MAINTENANCE BULLETIN

NO. 161
MARCH 1999

ALFA COMPANY

Figure 1 Back Up Ring And O-Ring Locations On Cylinder Head End Plug

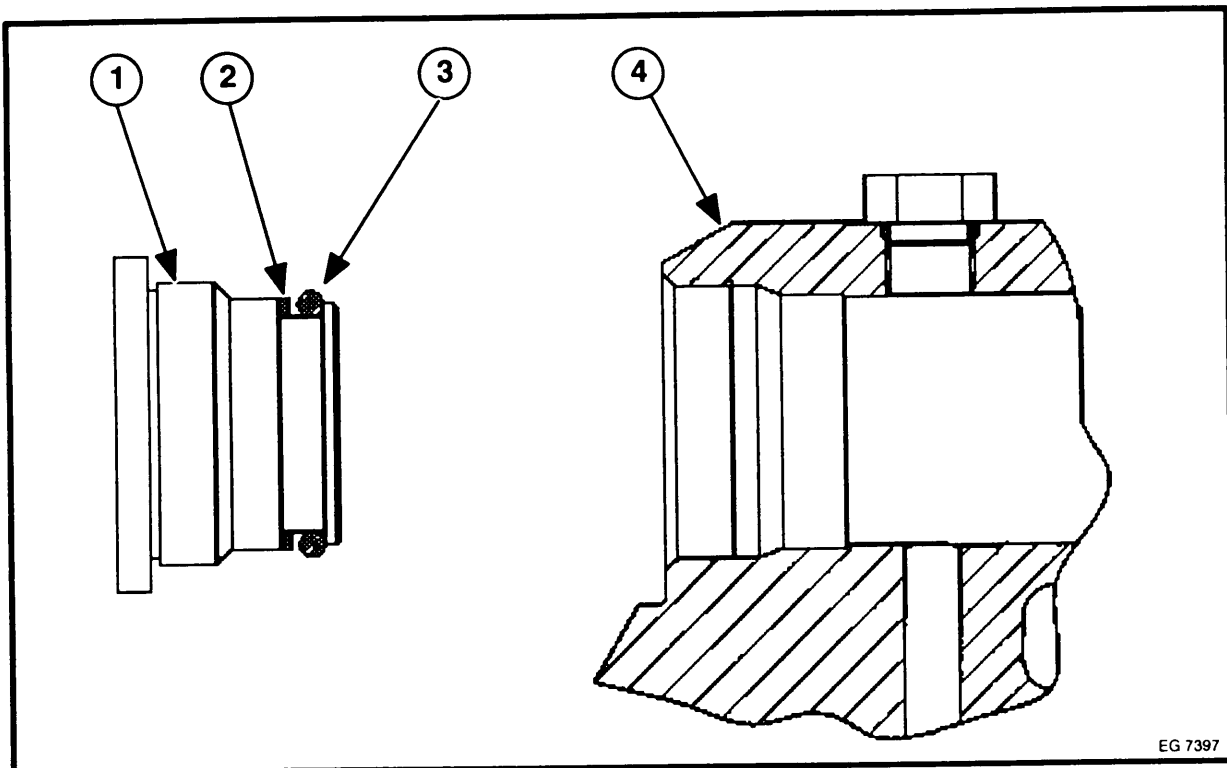
Description: The cylinder head oil rail end plug, back up ring and O-Ring are no longer serviced separately. A new service package containing a new end plug, back up ring and O-Ring has been created.

3. Lubricate new back up ring (2, **Figure 1**) and new O-Ring (3, **Figure 1**) with clean engine oil prior to installation onto new end plug (1, **Figure 1**). Install back up ring and O-Ring onto end plug as shown in **Figure 1**.

TO ASSURE A PROPER SEAL, BE CAREFUL, NOT TO GET ENGINE OIL ONTO THREADS OF END PLUG (1, FIGURE 1).

4. Apply a small bead of Loctite® #277 around the threads of the new end plug (1, Figure 1).
5. Install end plug into cylinder head oil rail port. Torque to 81 Nm (60 lbf-ft.)

Installation of Clip Improves Throttle Pedal Sensor Service Life

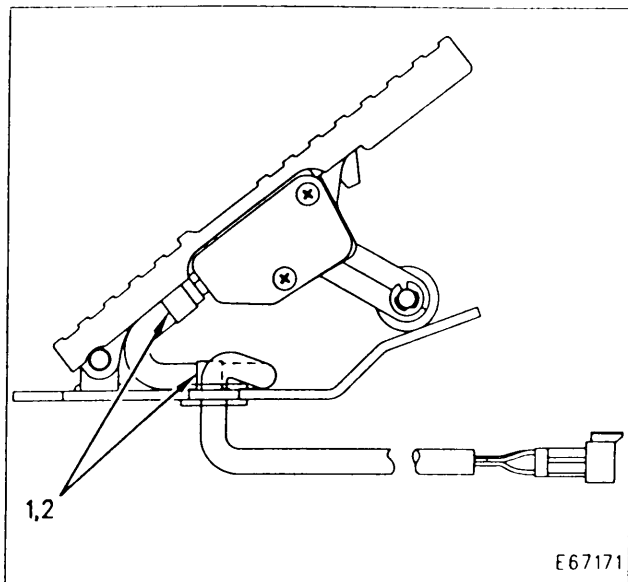
Description Of Change: A clip can be installed onto the pedal that will secure the throttle pedal wire harness. Without the clip the wire harness is able to move, resulting in wire deterioration. Installation of this clip will increase the service life of the wire harness.

Adaptable To: 160-6366 Clip (1) and 160-6365 Screw (2) are effective with 988F Series II (2ZR1157-Up) Wheel Loaders, and are adaptable to first production for all other machines listed.

159-8661 STIC Control Group

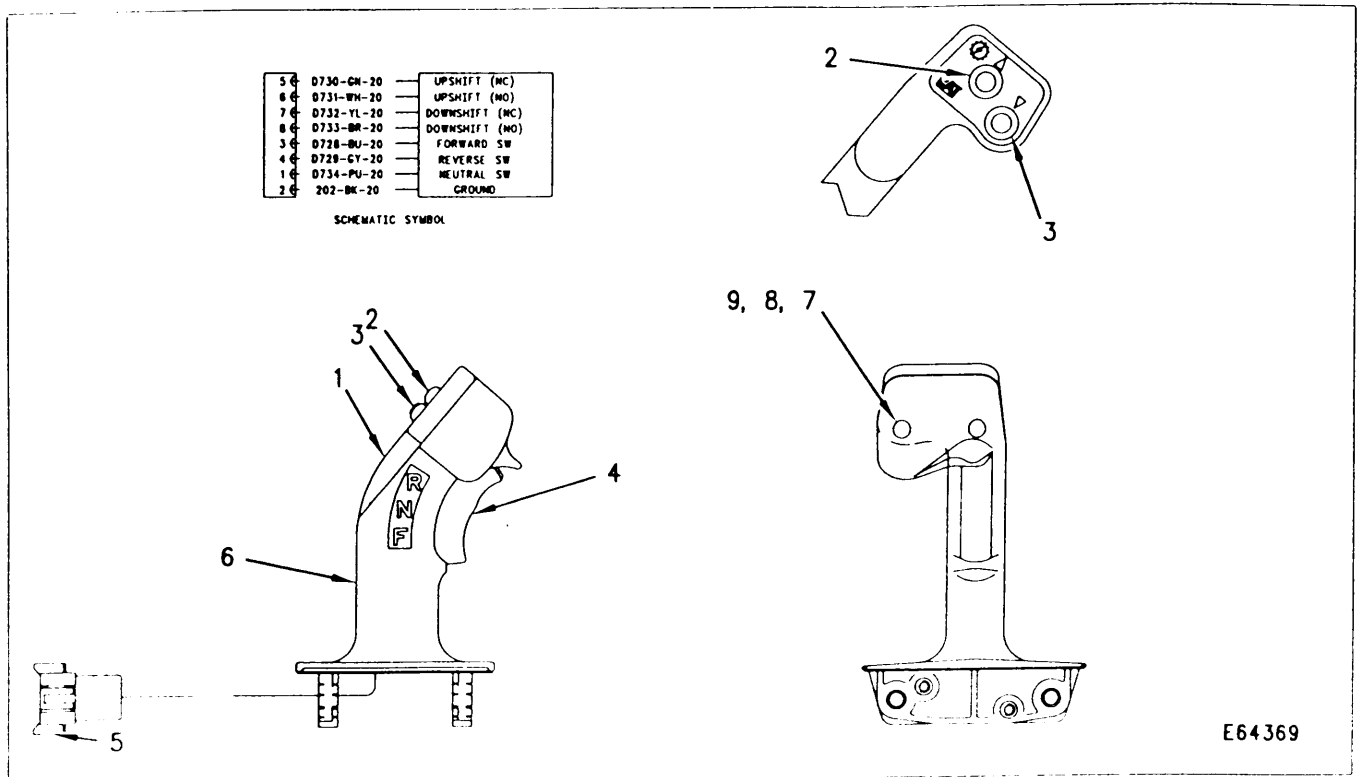
Description Of Change: A new transmission control group STIC (Steering Transmission Integrated Control) is now available featuring individually serviceable up-shift, downshift & directional switches.

Adaptable To: The new 159-8661 STIC Control Group is a direct replacement for the former 117 0298 and 136-1155 STIC Control Groups. The new 159-8662 Cap Assembly is a direct replacement for the former 136-1153 Cap Assembly.

Typical Steering Controls

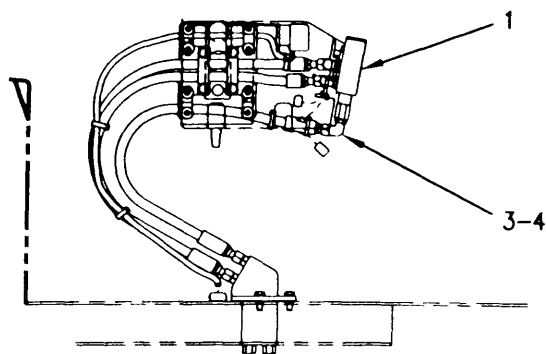
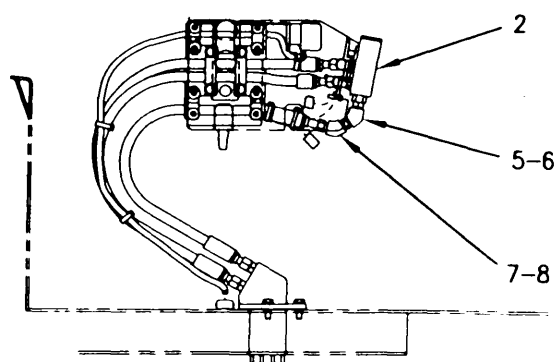
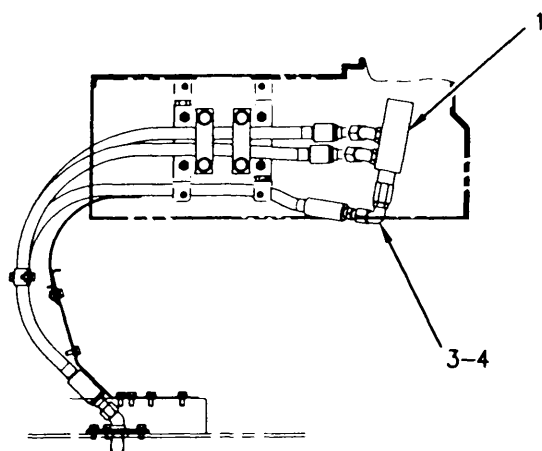
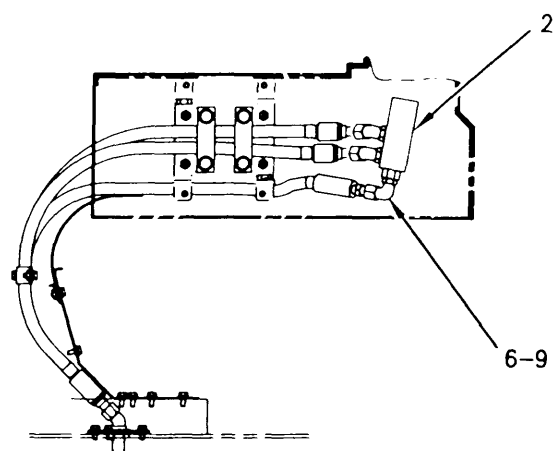
Description Of Change: A new pilot valve replaced the former pilot valve for steering control. The new pilot valve improves steering operation, control, and stability. Noise is also reduced.

Note: Apply equal torque to mounting bolts for new 143-2855 Pilot Valve (1) to prevent distorting the valve body.

Note: Important - use an 11/16" open end wrench on the handle of the valve to secure the joystick locknut. Otherwise side loads can be transferred to the valve plungers, contributing to sticky operation.

View of 8X-4966 Trailing Unit Control.

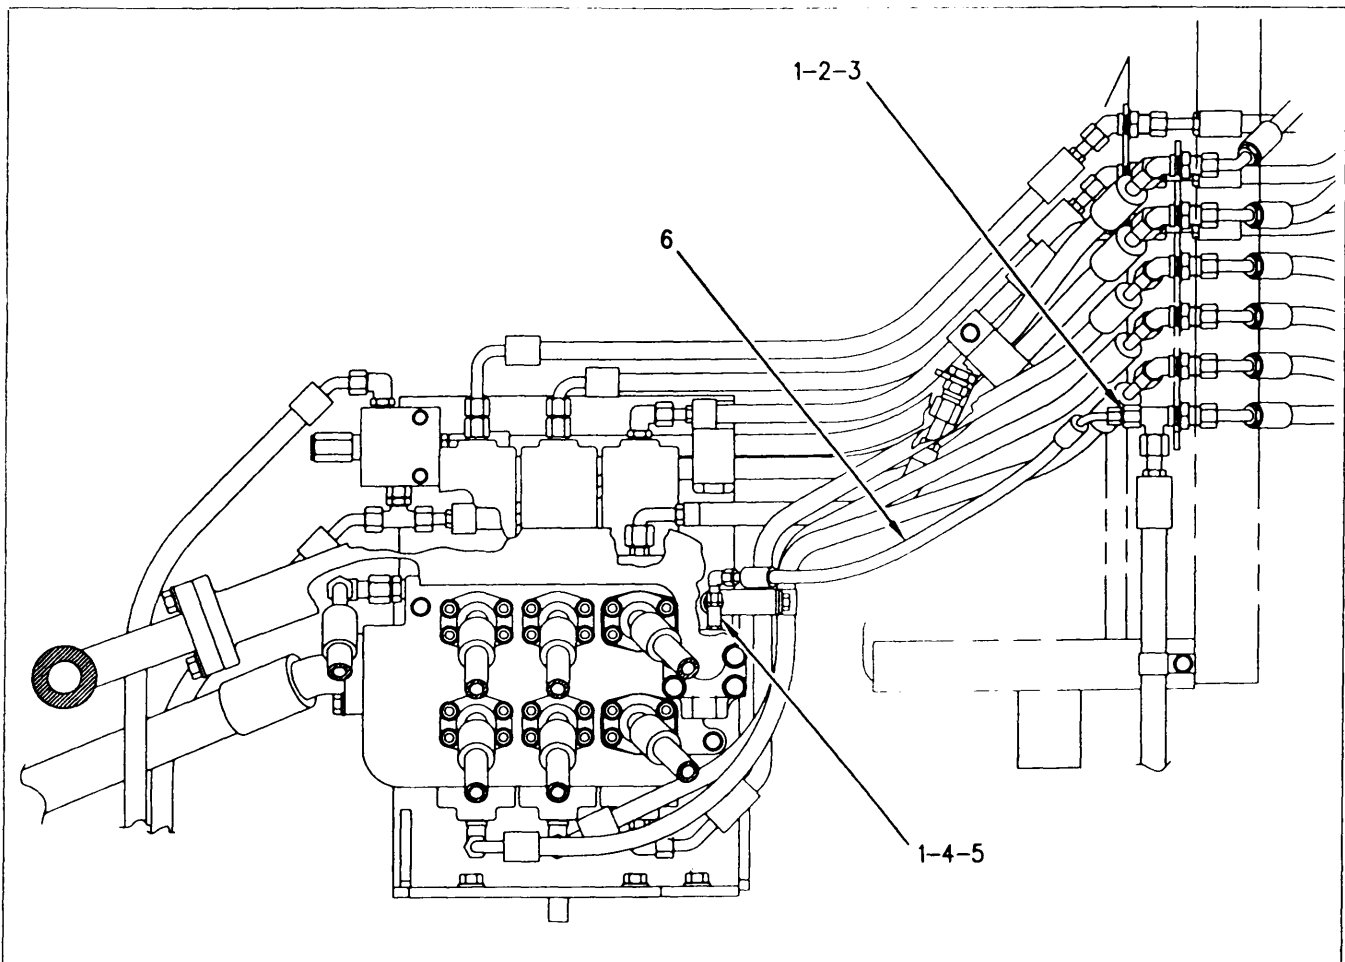
Description Of Change: A check valve and vent line has been added to the trailing unit control group to prevent the scraper bowl from dropping when trying to modulate after a long haul with a loaded bowl

Adaptable To: The changes to the 8X-4966 Trailing Unit Control are effective with 621F (4SK780) and 627F (1DL555) Wheel Tractor Scrapers. To adapt earlier machines, see the referenced Service Magazine.

Figure 1 - Article 95-5-22

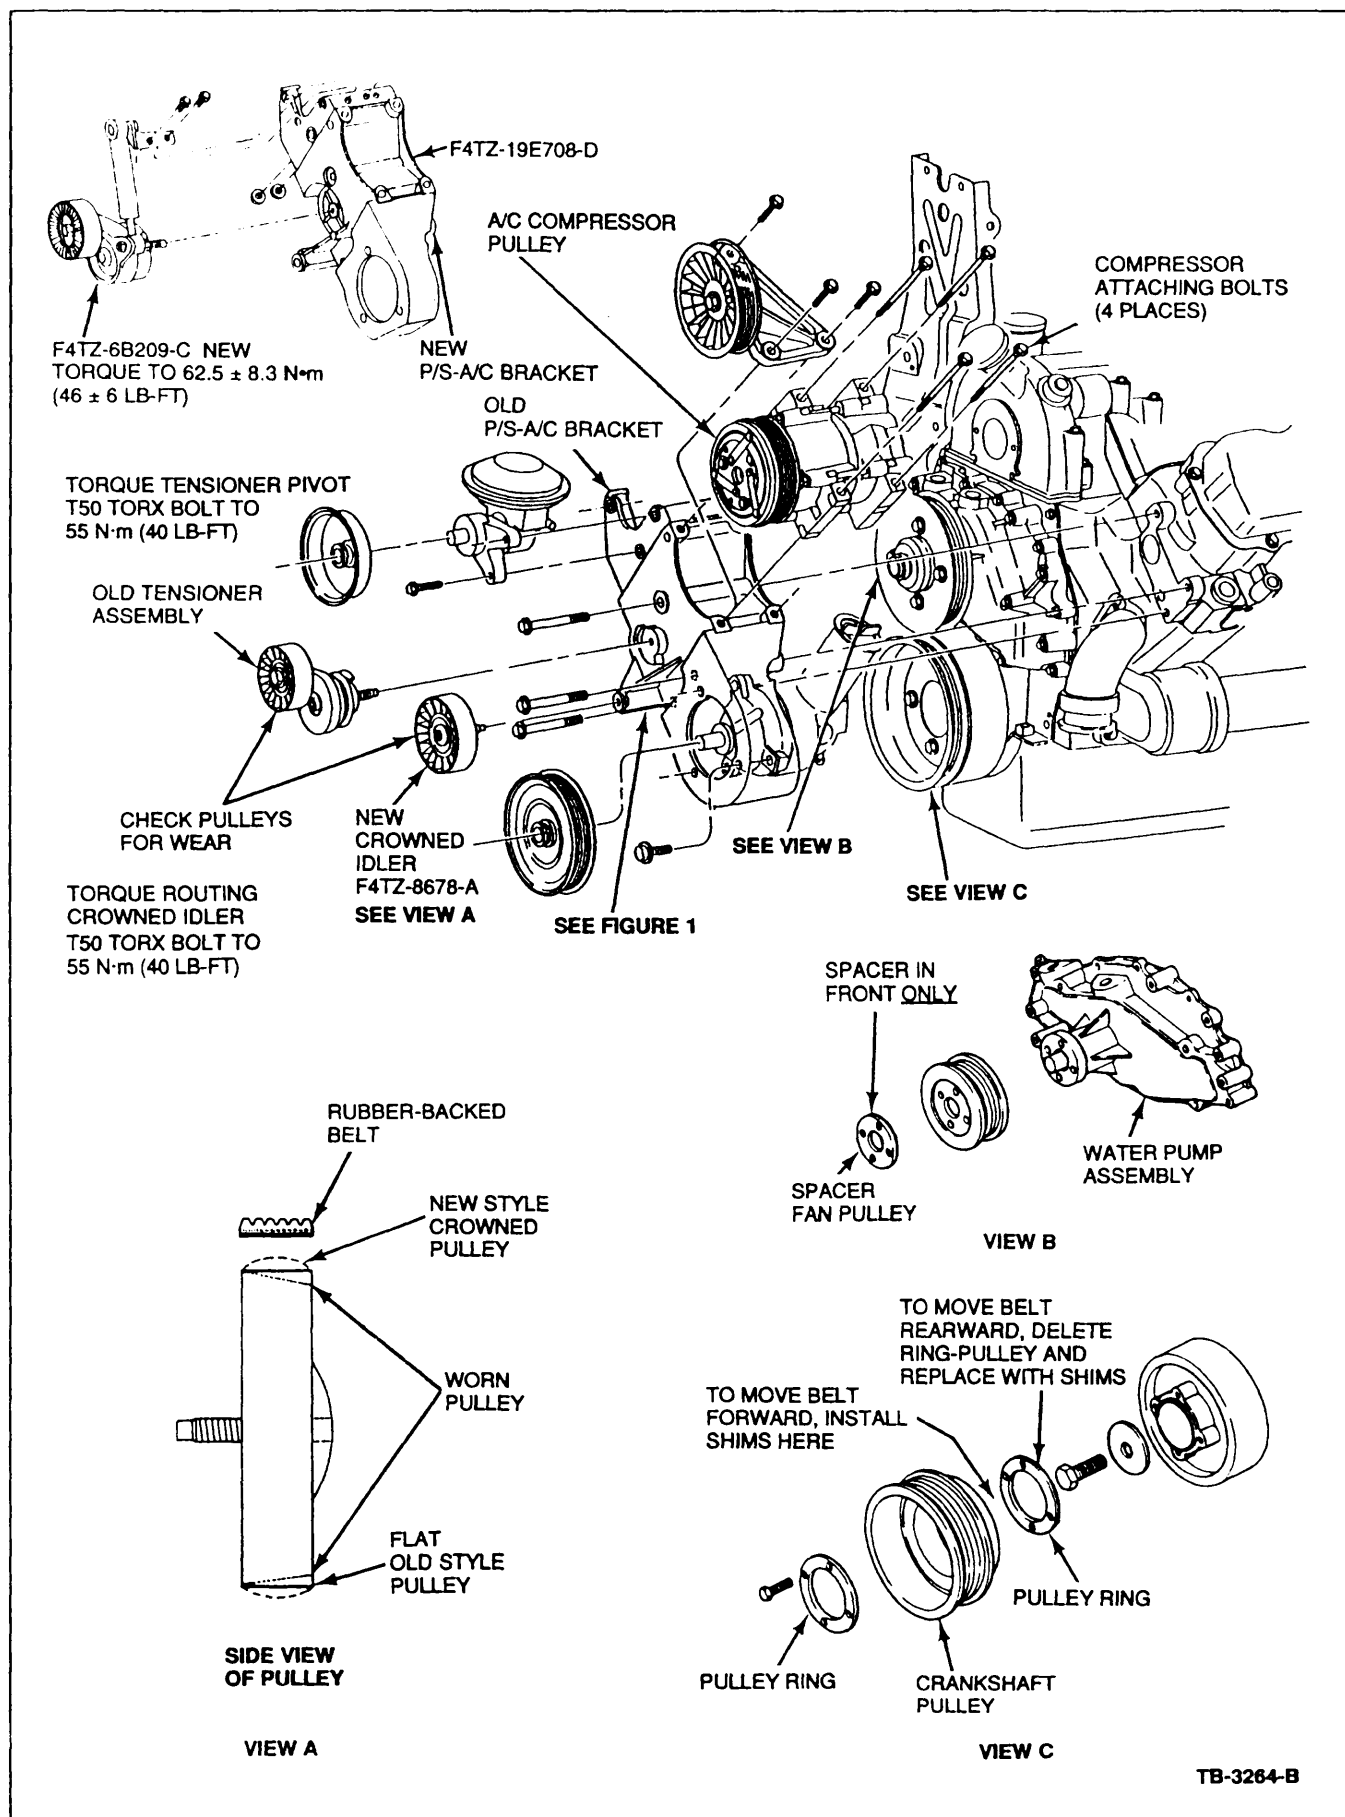
1. Install the A/C-P/S-V/P bracket (F4TZ-19E708-D) to the cylinder head. Tighten the three (3) fasteners to 47.5 N·m \pm 7.2 N·m (35 lb-ft \pm 5 lb-ft). Refer to Figure 1.
2. Install the tensioner (F4TZ-6B209-C) using the T50 Torx bit and tighten to 62 N·m \pm 9.4 N·m (46 lb-ft \pm 7 lb-ft). The sub-bracket is attached to the flange on the main bracket adjacent to the vacuum pump location. Use two (2) new bolts (N605906-S2) and nuts (N620481-S2) and torque to 27 N·m \pm 4 N·m (20 lb-ft \pm 3 lb-ft).

**NOTE: VERIFY THAT THE PULLEY IS CROWNED:
F4TZ-8678-A. REFER TO FIGURE 1.**

Figure 2 - Article 95-5-22

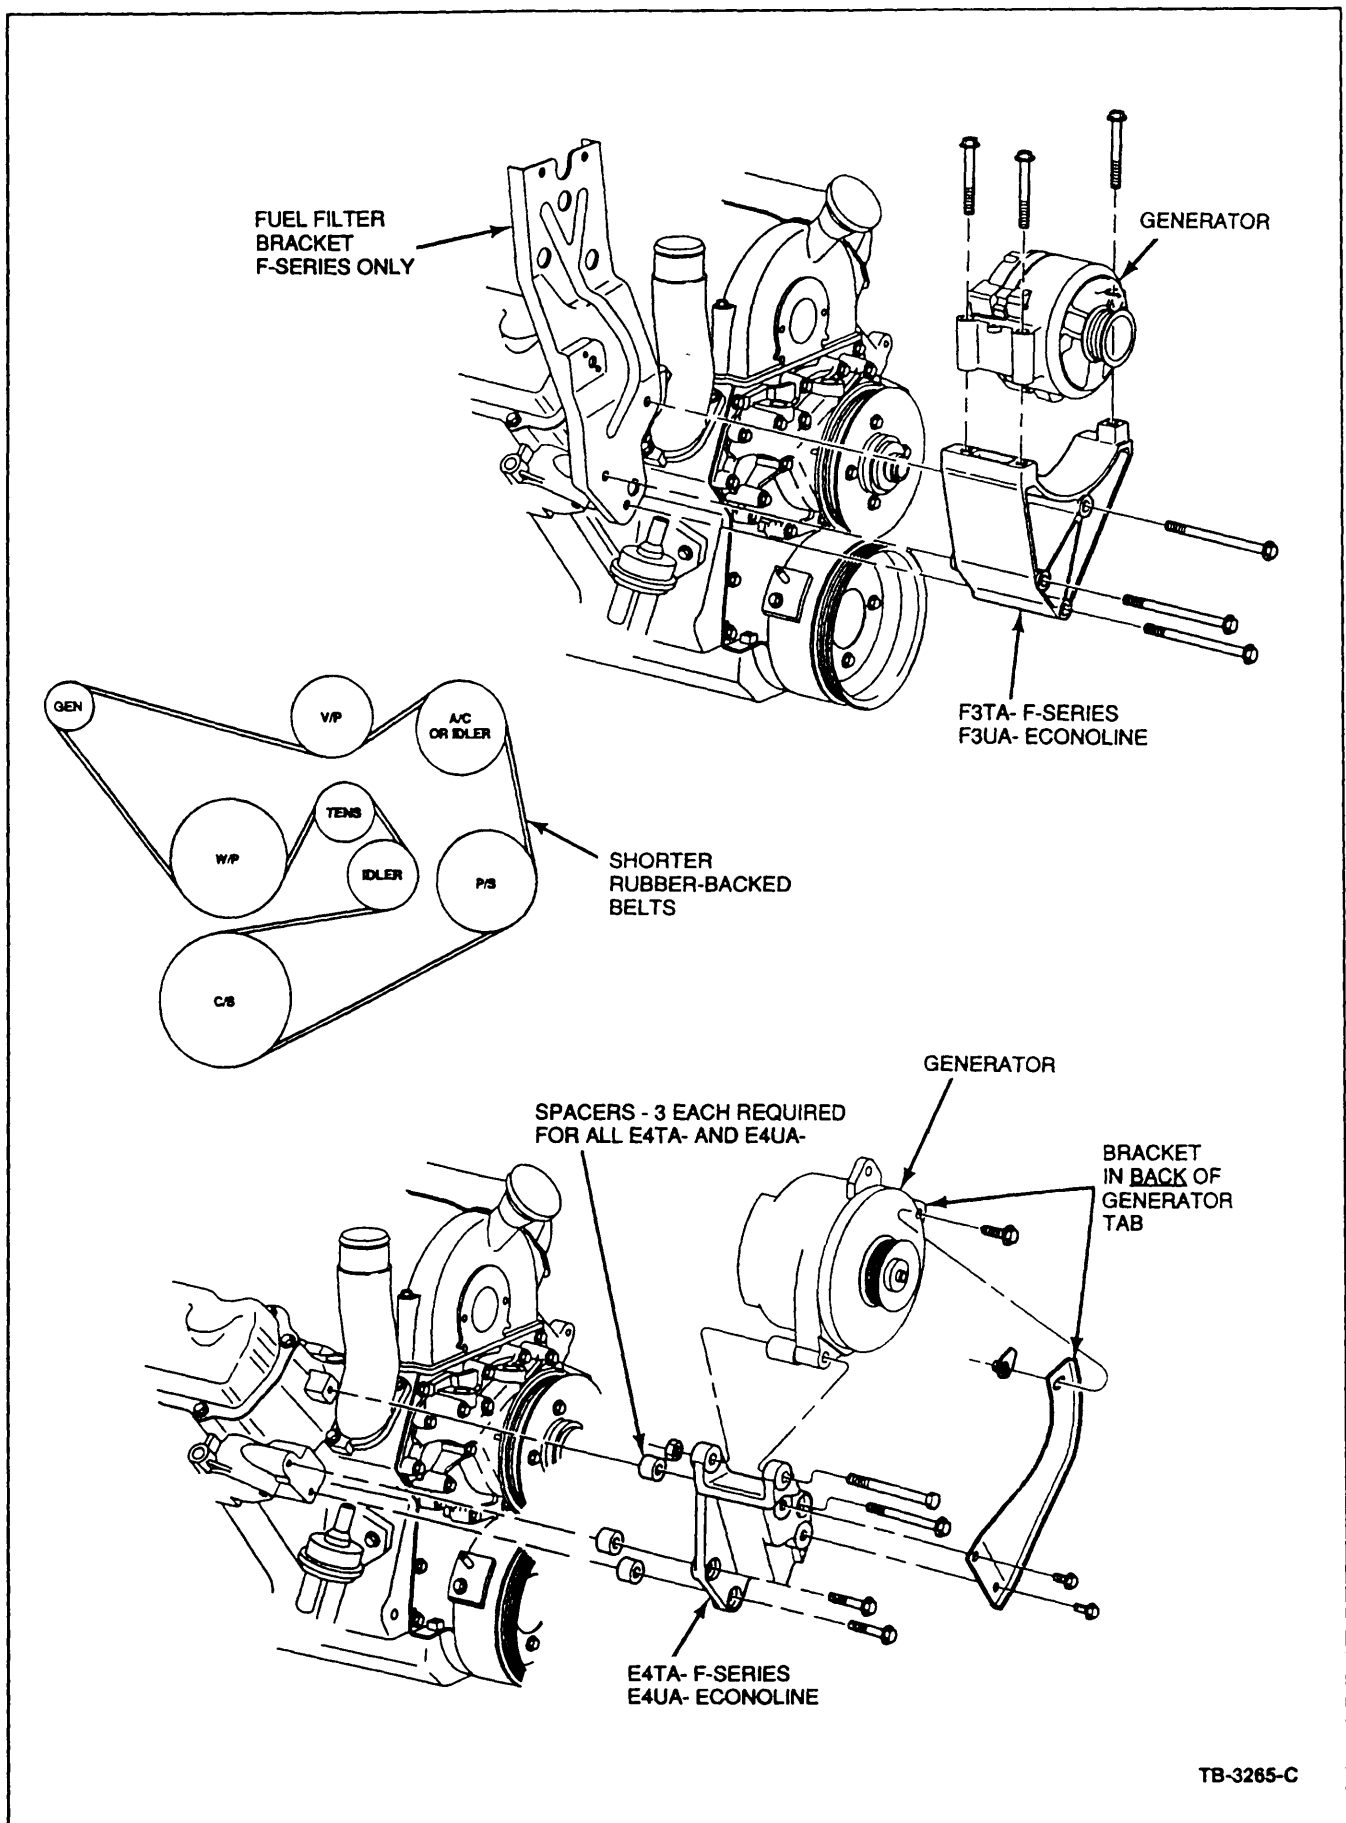
8. Verify assembly sequence of Navistar shims (E3TZ-6B306-A) $0.090"$ (2.3mm) at crankshaft-water pump pulleys, refer to Figure 2. The preferred assembly is with a pulley ring (E3TZ-6B306-A) in front and in back of the crank pulley and the spacer plate in front of the water pump pulley, only. Tighten to 32.5 N·m ± 3 N·m (24 lb-ft ± 2 lb-ft).

- a. Loosely route the belt over all pulleys except the routing idler. Refer to Figure 2.
 - b. Assure that the belt fits correctly in all grooved pulleys.
